# 2ND AND VIRGINIA

## RESPONSE TO BOARD GUIDANCE

#### 1 ADDITIONAL VIEWS

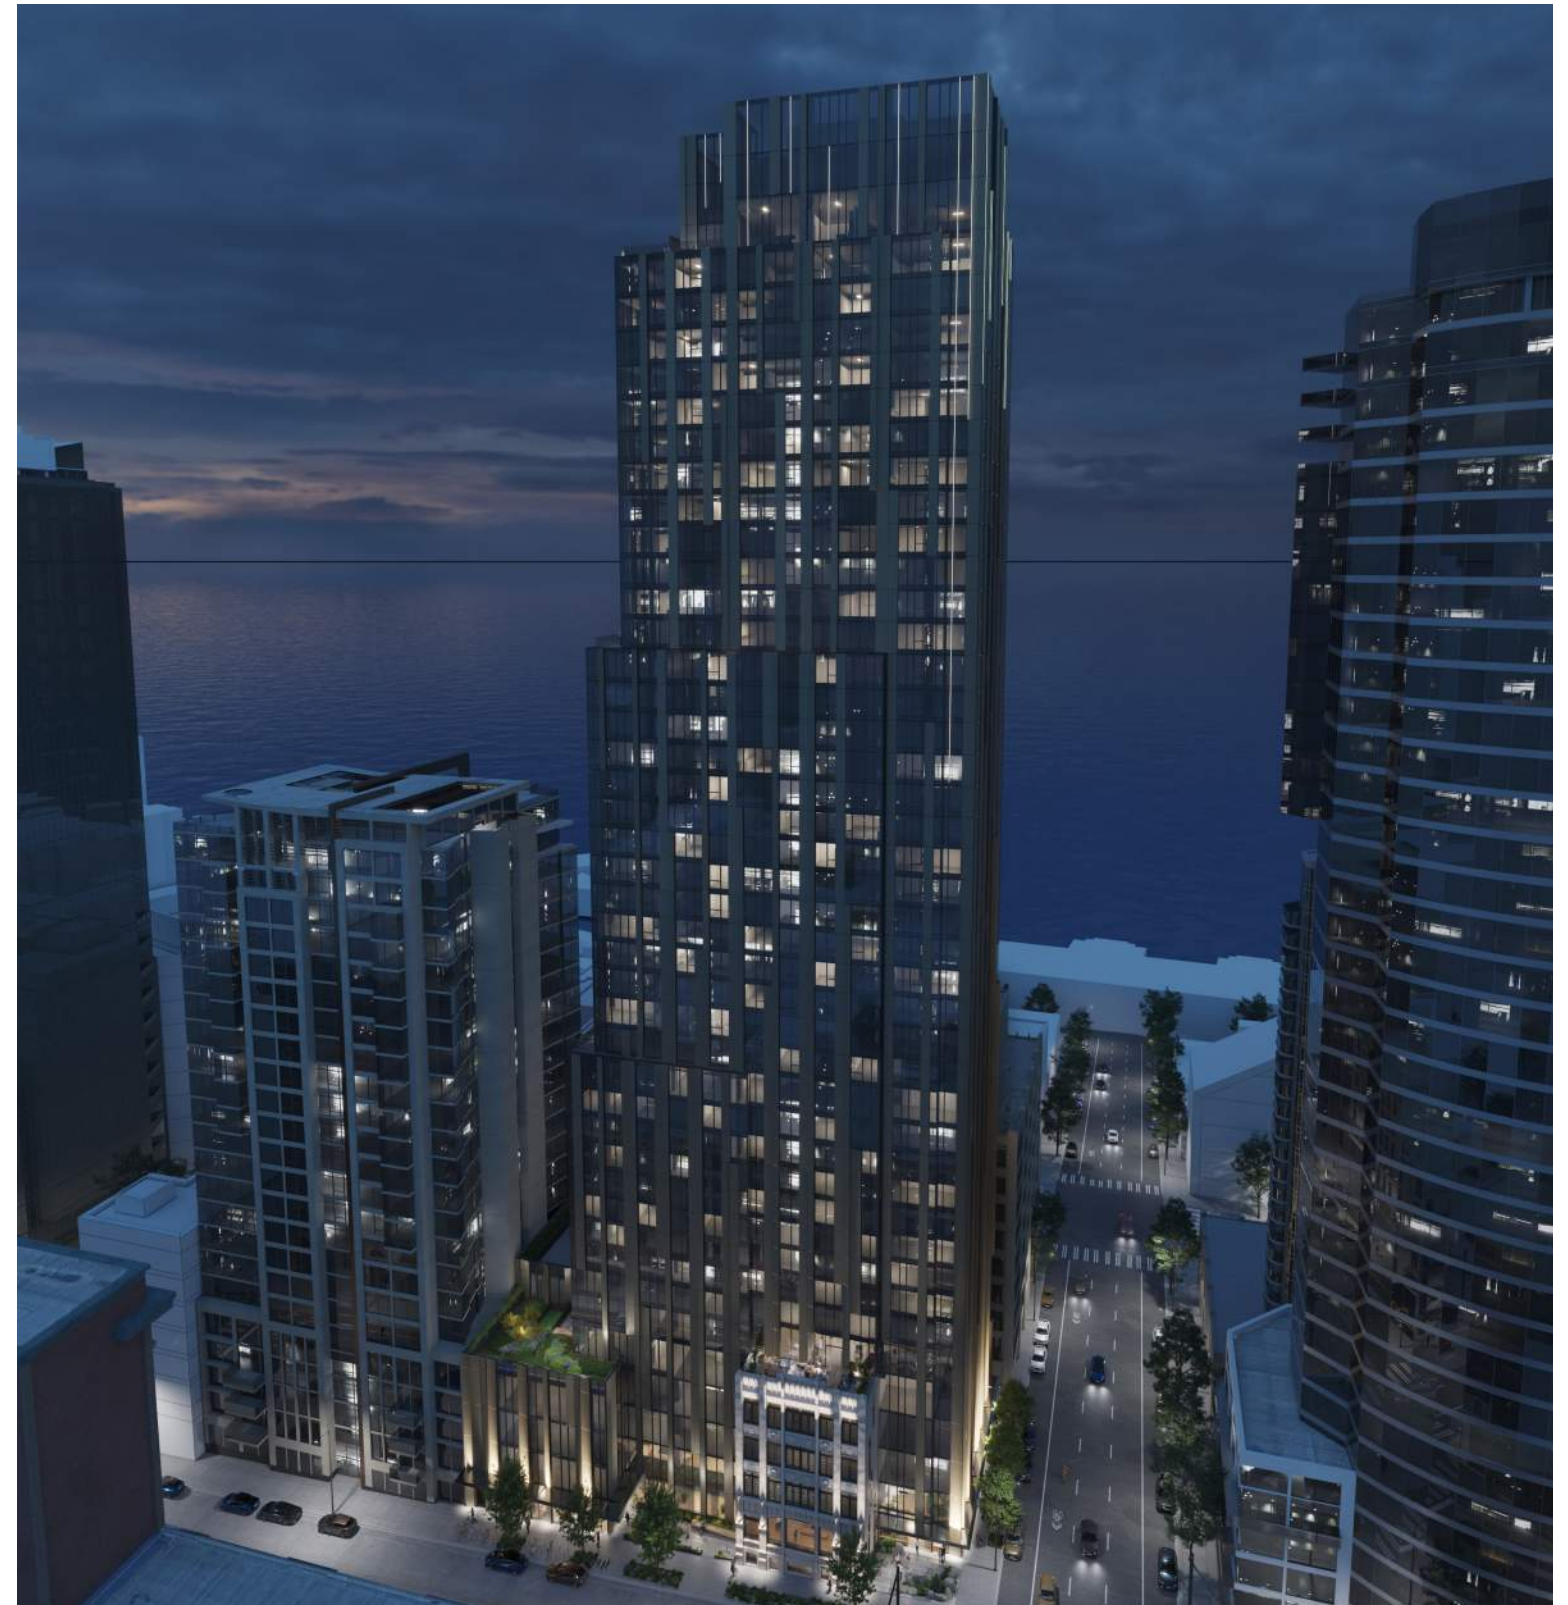
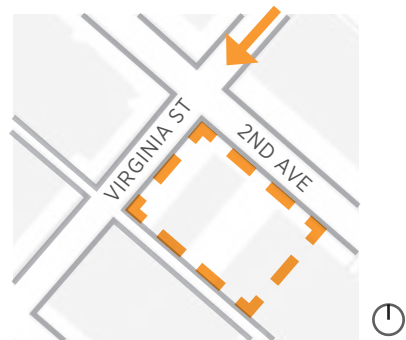
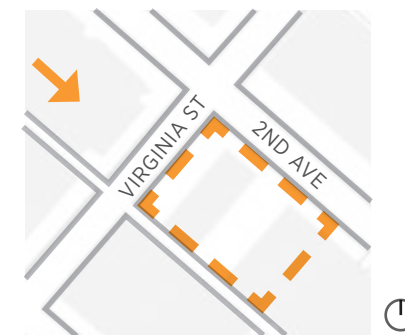
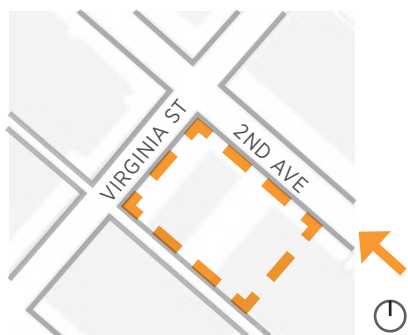
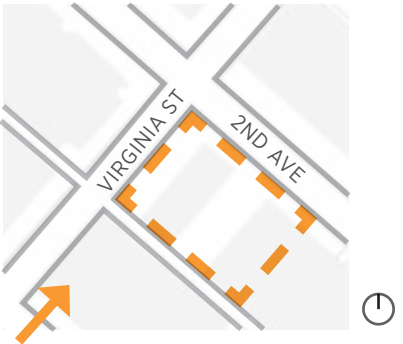
The Board appreciated the additional views, page 24 for example, provided by the applicant team. The Board would like to see these views (night and day) provided at the next meeting, illustrating how the tower top has been further enhanced to add to the skyline and support the building identity. The Board would like to see the materiality of adjacent buildings in future images as this will inform guidance related to how the tower sits within the skyline context.

The design team has provided several overall and tower top renderings in both night and day conditions with the context of adjacent buildings.

**2** APPROPRIATELY SCALED TOP

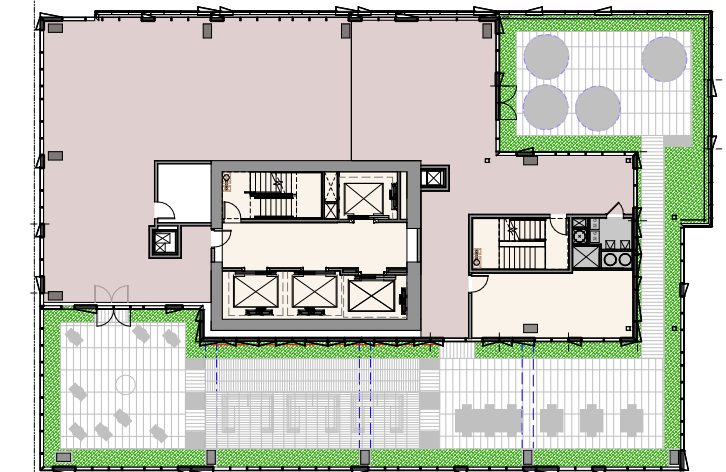
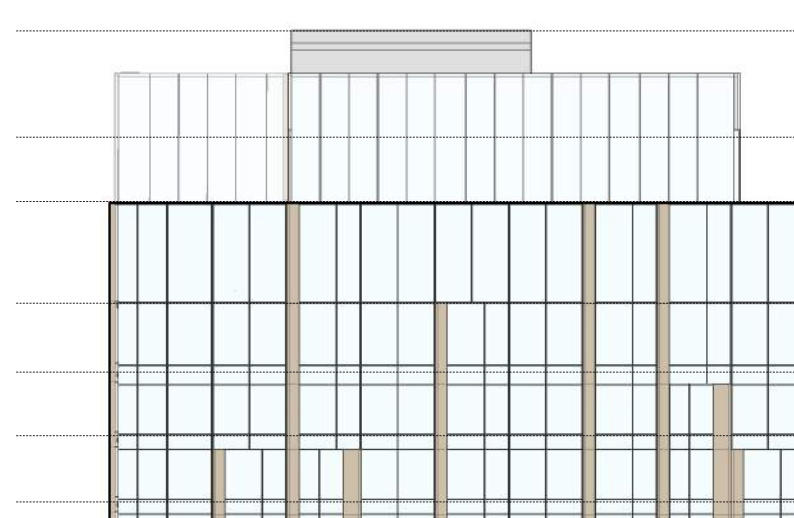
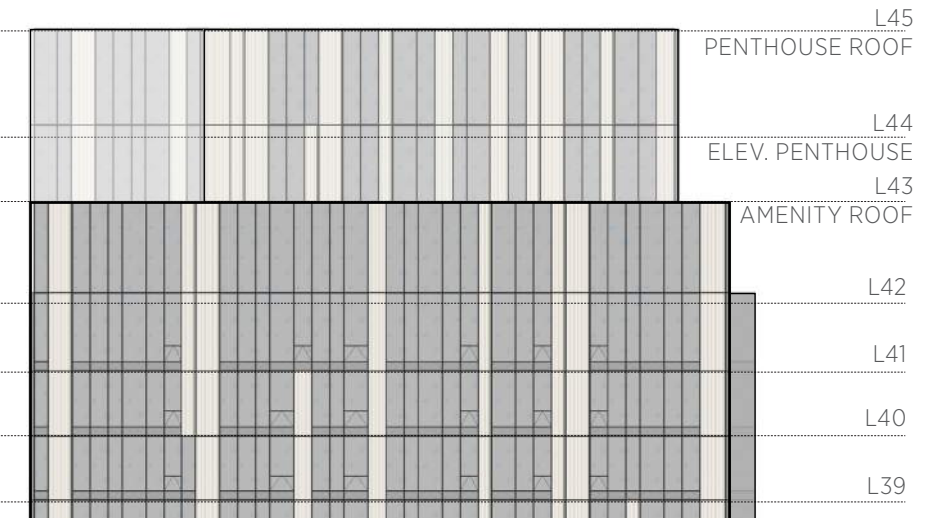
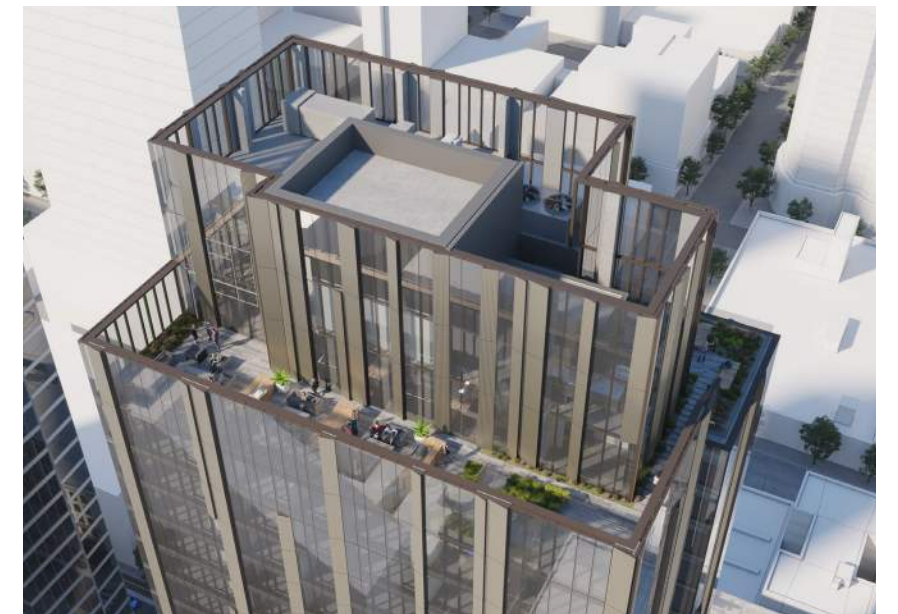
The Board expressed some concern with the tower's top terminus, providing guidance to further refine the tower top to be more in keeping with the design rules (stepping concept) established by the body of the tower form. The top should be scaled appropriately (large enough massing moves) to create a logical terminus form in keeping with the tower proportions and form.

Massing: In order to simplify the rooftop massing, the facade has been raised to cover the elevator/ core overrun, enclosing all mechanical equipment within one expression, which originates at the ground and extends up toward the sky.

Facade: In contrast to the opacity seen in the previous EDG scheme, the tower terminus' west facade has been broken down into a lighter but still continuous facade treatment. The current design has evolved to bring the solid facade patterning created by the metal panels to the top of the screening wall.

#### 3 SOUTH PARTY WALL

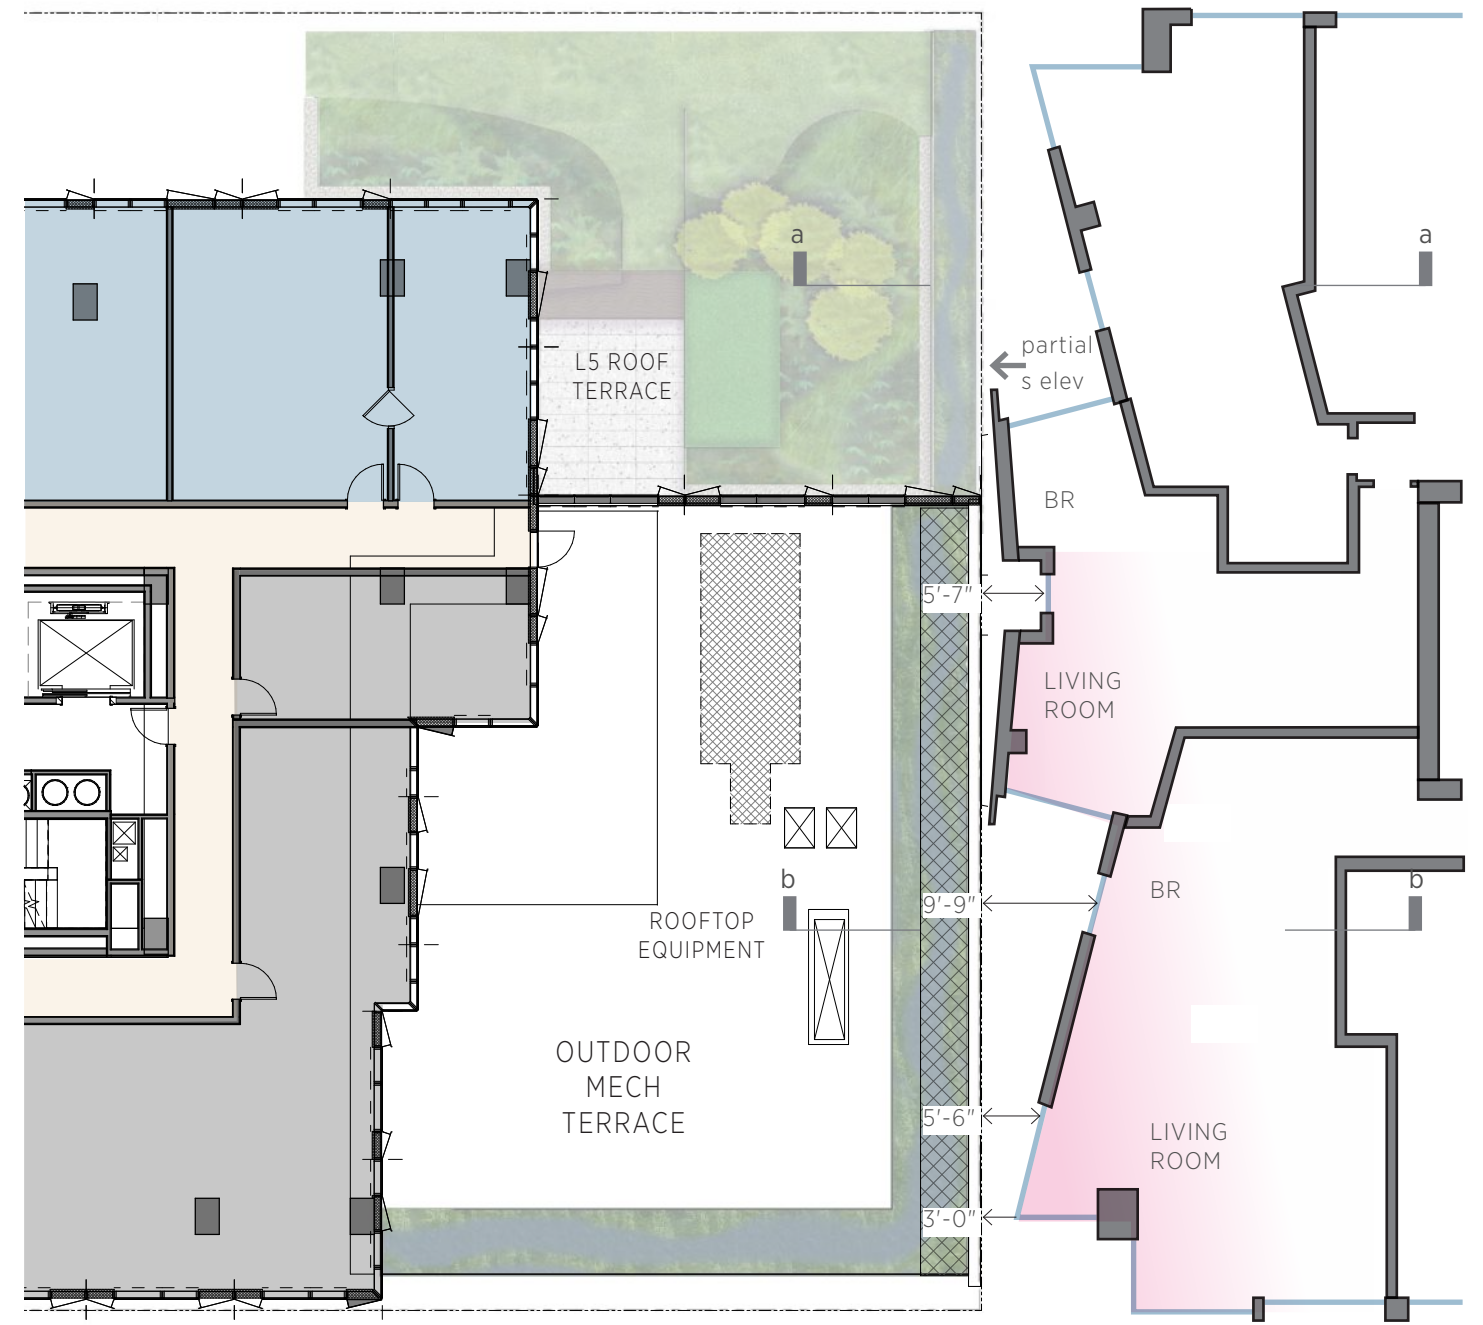
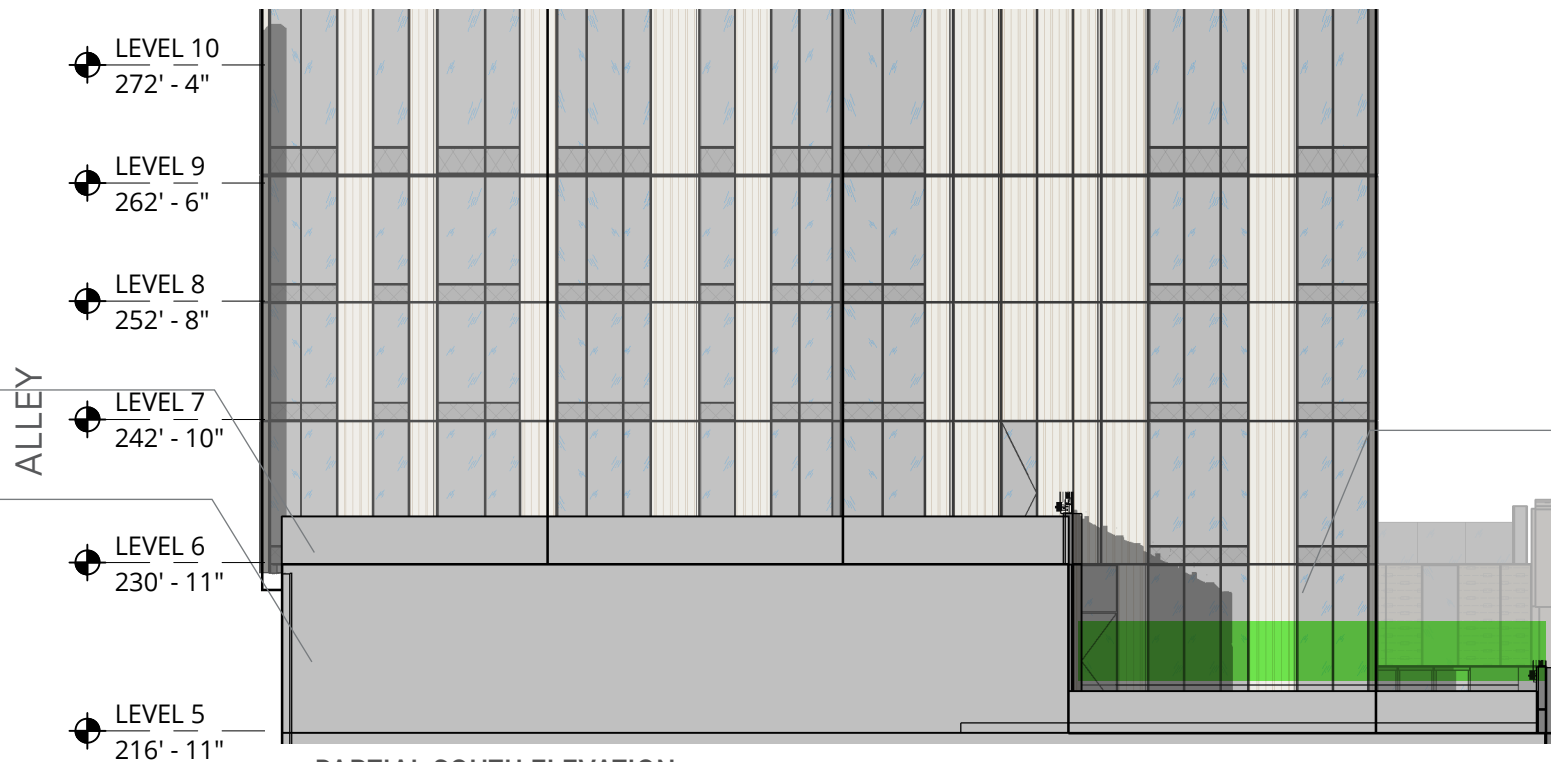
At the next meeting, the Board requested more information detailing the resulting party wall condition along the south edge.

In addition to the tower setback on the south, the design team has made respectful considerations to the abutting property. The project proposes an outdoor roof terrace at the southeast corner on Level 5 with a five feet deep landscape buffer. This buffer will be a pleasant view from the neighboring property, and provide visual and audible privacy between the buildings. As the building steps to Level 6 at the west, another 5' deep landscape buffer is proposed, along with an acoustical barrier to mitigate any mechanical noises transference to the neighboring property. One unit of the neighboring building will face a natural party wall.

4 VERTICAL LANGUAGE

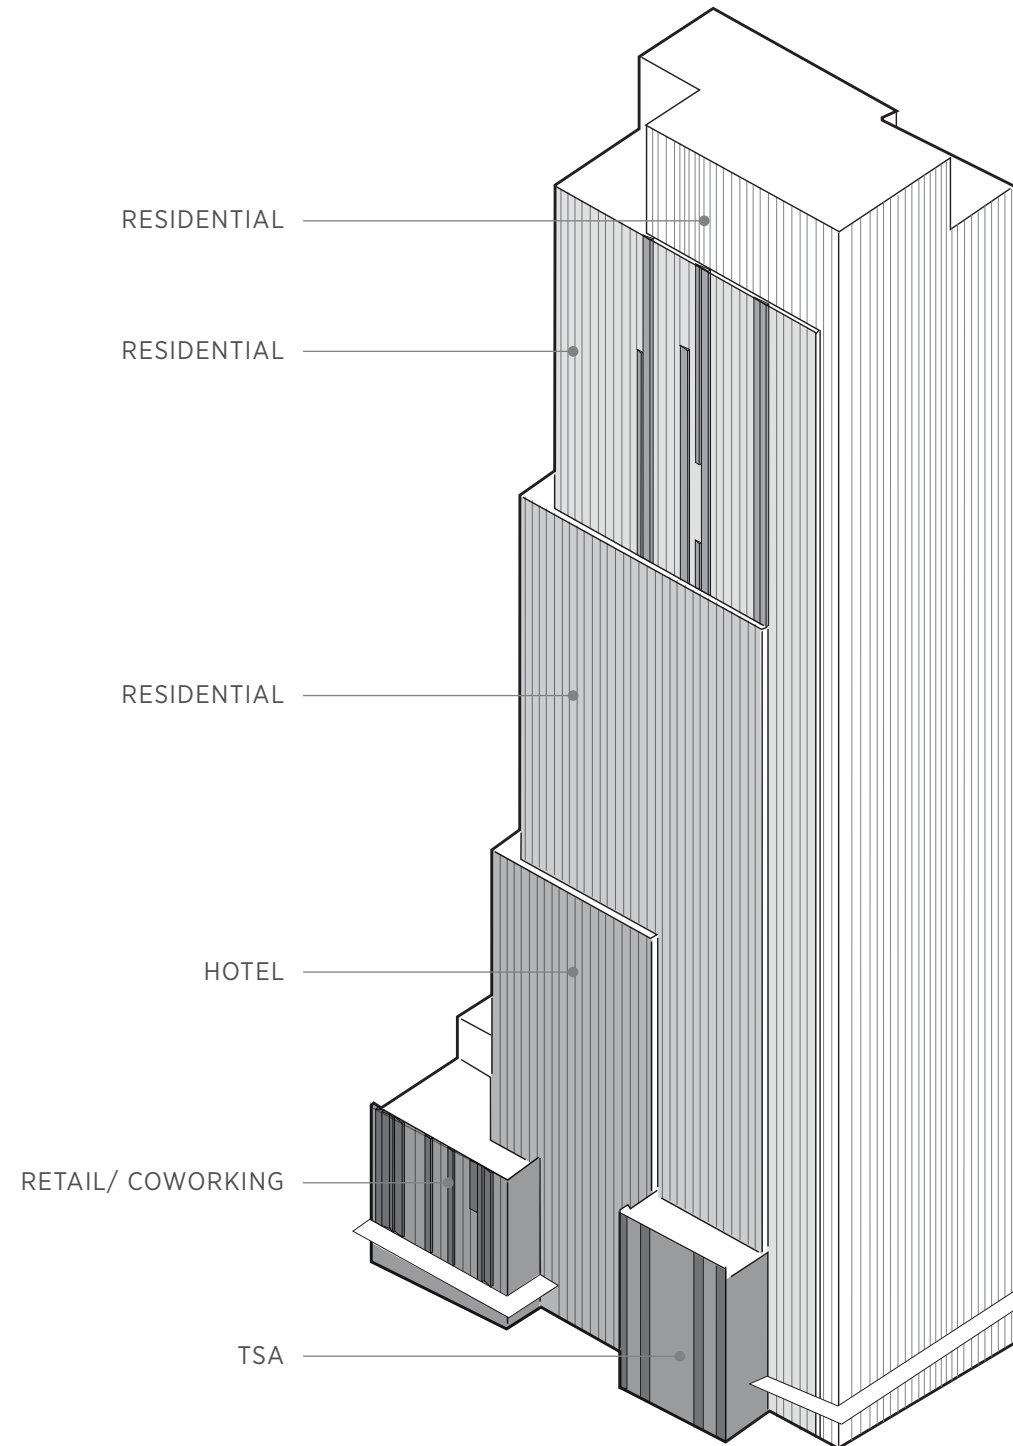
Moving forward, the Board provided guidance to demonstrate how the vertical language of the tower would be carried down through the street-level expression.

The tower's telescoping form is informed by programmatic transitions throughout the tower's mass, and expresses its three key uses: retail/ coworking, hotel and residential, emphasizing the tower's mixed-use nature.

Angled facade panels reference historic pilasters on the landmark Terminal Sales Annex Building below, further reinforcing the tower's connecting to street level as well as its past. Subtle changes in the panel texture reinforce the massing strategy.

With its unique facade panels, originating at the ground and reaching vertically up to the sky, the project strives to become a wayfinding device within the city.
